ECN/PCN No.: M1177

For Manufacturer			
<b>Product Description:</b> <b>RJ45 10/100 Base-T / 1 X USB Combo, w/ LEDs, Ext Temp</b>	<b>Abracon Part Number / Part Series:</b>  <p style="text-align: center;"><b>ARJ-169</b></p>	<input type="checkbox"/> Documentation only <input checked="" type="checkbox"/> ECN <input type="checkbox"/> EOL	<input type="checkbox"/> Series <input checked="" type="checkbox"/> Part Number(s)
<b>Affected Revision:</b> <p style="text-align: center;">B</p>	<b>New Revision:</b> <p style="text-align: center;">C</p>	<b>Application:</b>	<input type="checkbox"/> Safety <input checked="" type="checkbox"/> Non-Safety

Cause/Reason for Change:  
Adding additional production line. Updating graphics for datasheets.

**7.1 DIP Wave Soldering Profile**

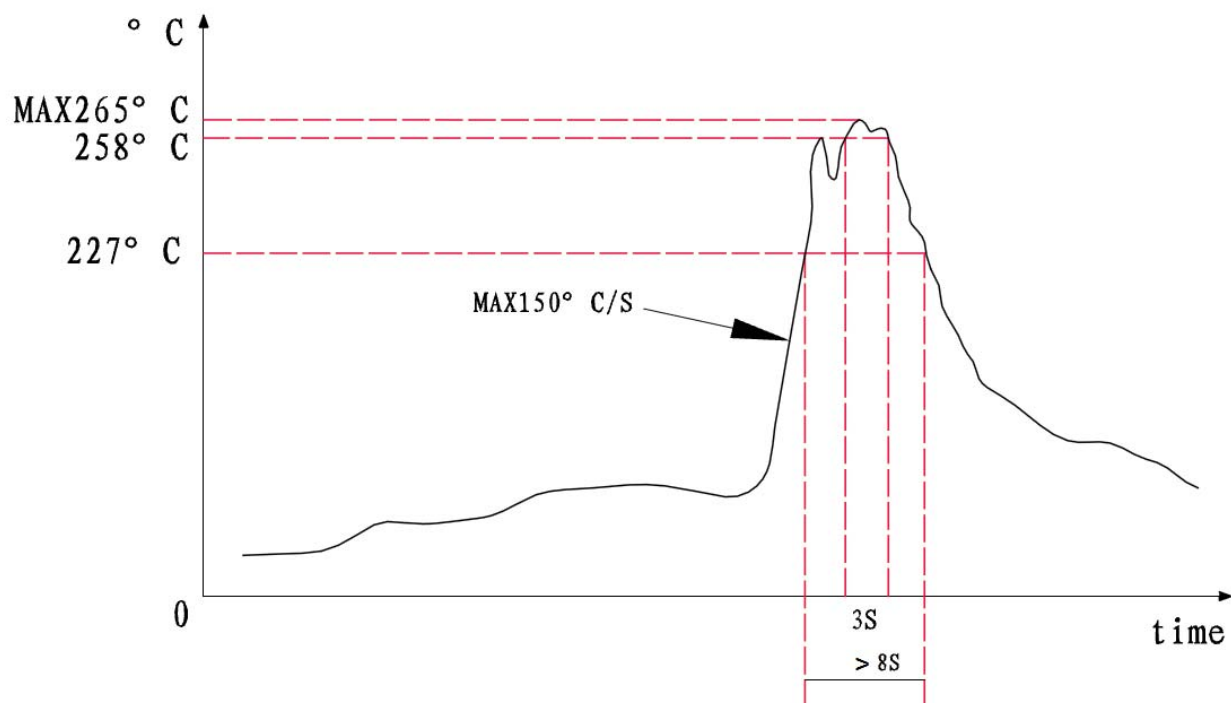
Peak temperature(Tp) : 265°C  
 Peak temperature(Tp) time : 3sec max

**8.0 Packing: 50pcs/tray**  
**Weight: 12.1 grams / pcs**

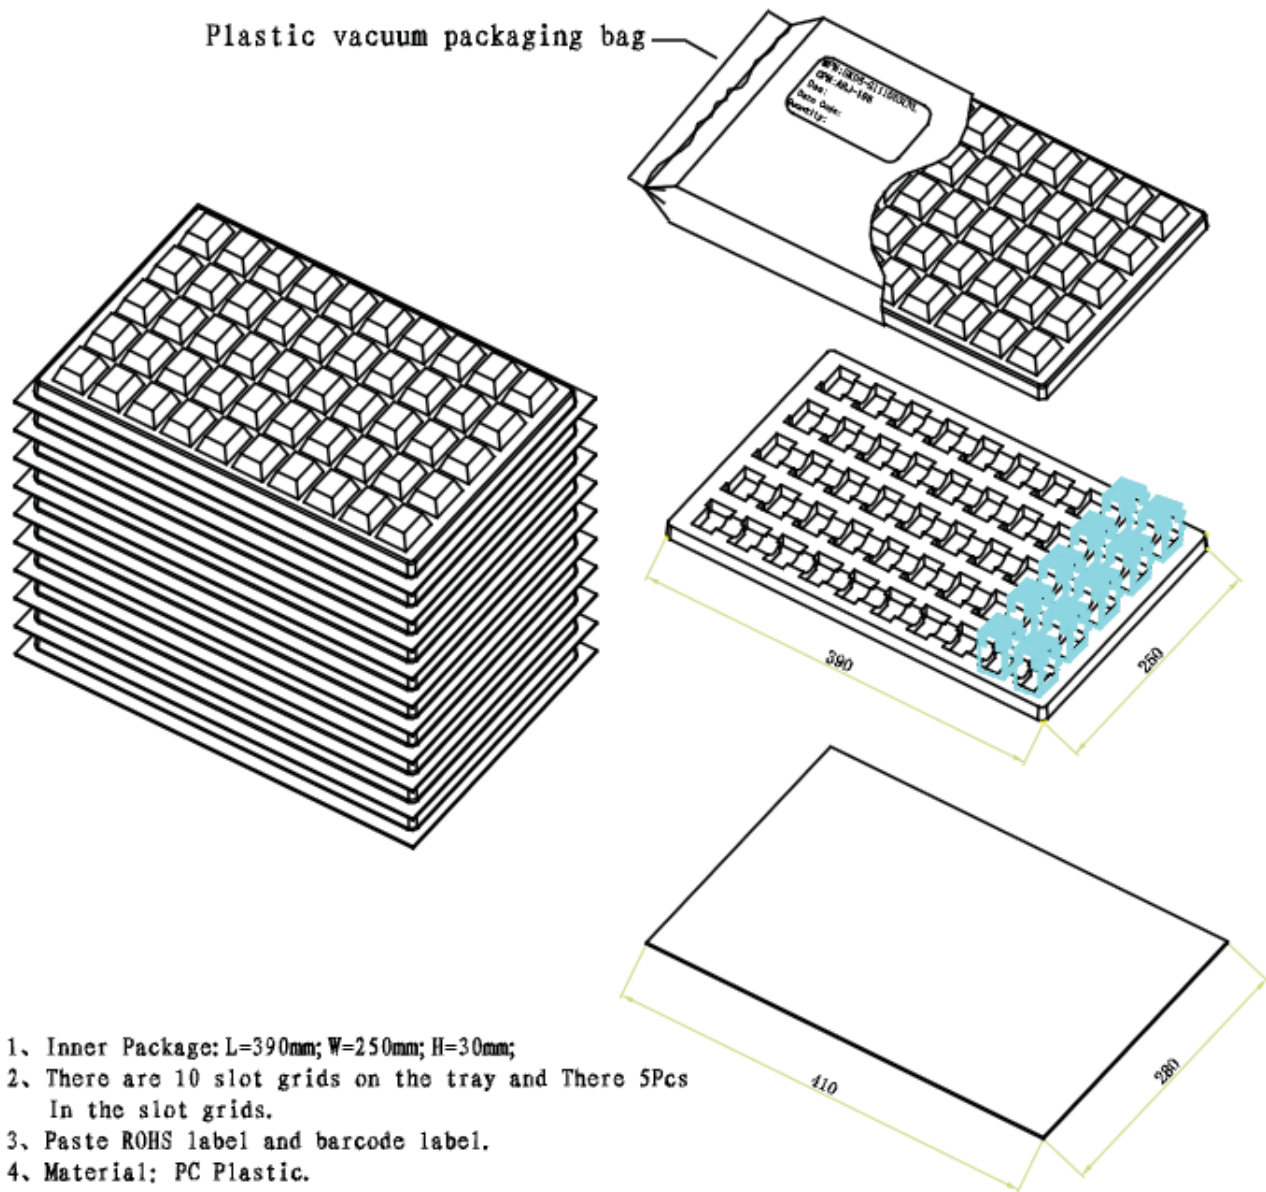
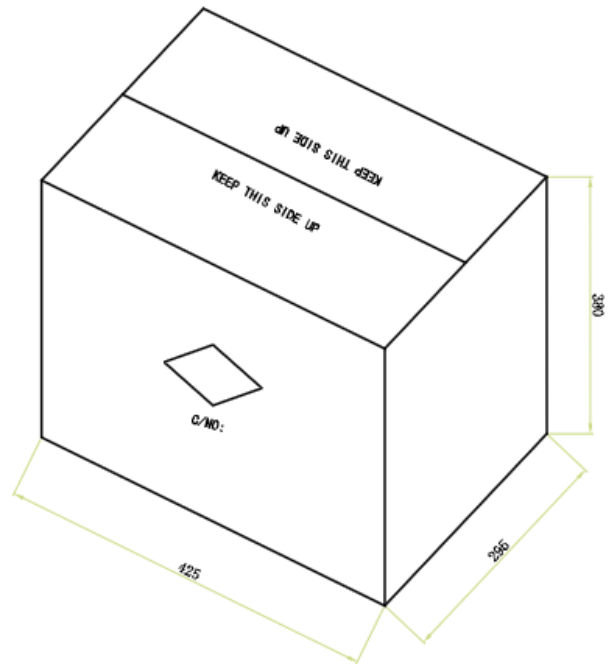
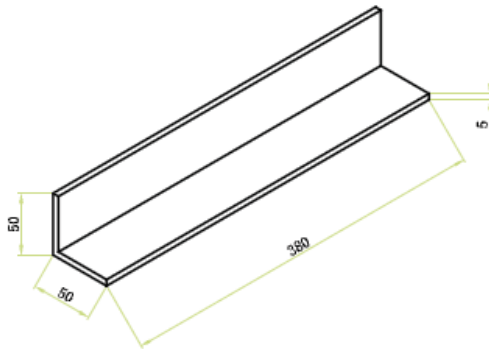
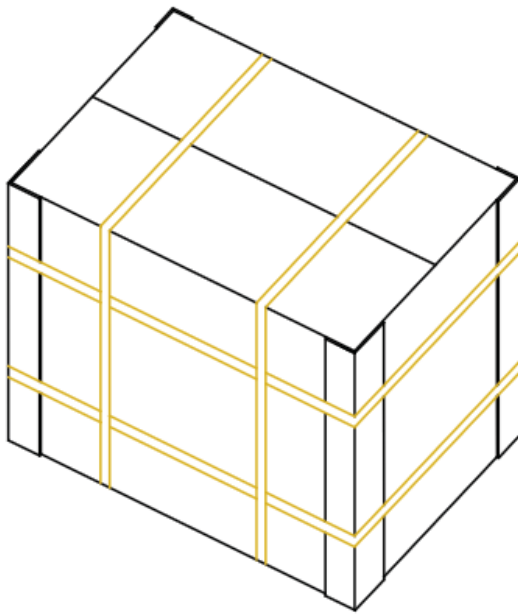
**Packing Material: PC Plastic**

Outer carton unit (optional): 500 pcs/10 trays/box

1. Package Box : L=425mm; W=295mm; H=380mm;
2. Package Box contain 10 PCS inner package Trays.
3. Material: US CARD+kraft papers.
4. There are 500 PCS products in the Package Box.

## 7.1 Wave Soldering Profile

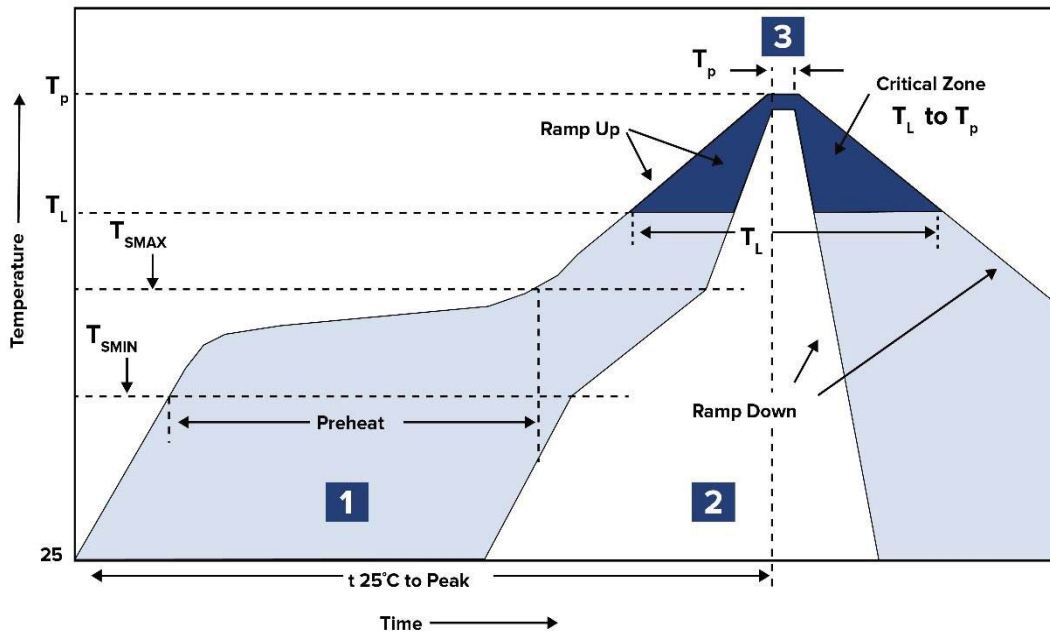
Zone	Description	Temperature	Times
1	Preheat	$T_{SMIN} \sim T_{SMAX}$ 150°C ~ 180°C	60 ~ 120 sec.
2	Reflow	$T_L$ 227°C	8 sec.
3	Peak heat	$T_P$ 265°C	3 sec. MAX

**8.0 Packaging**

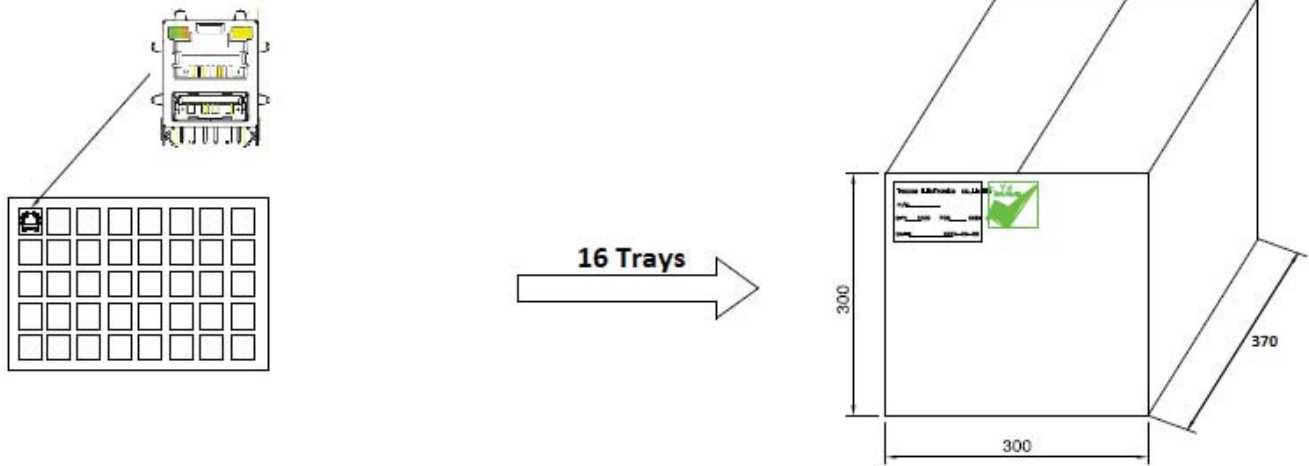
**Bulk/Tray (40pcs/tray, 16 trays/carton)**

**Carton Size : 370 X 300 X 300 mm, weight is 9.5Kg**
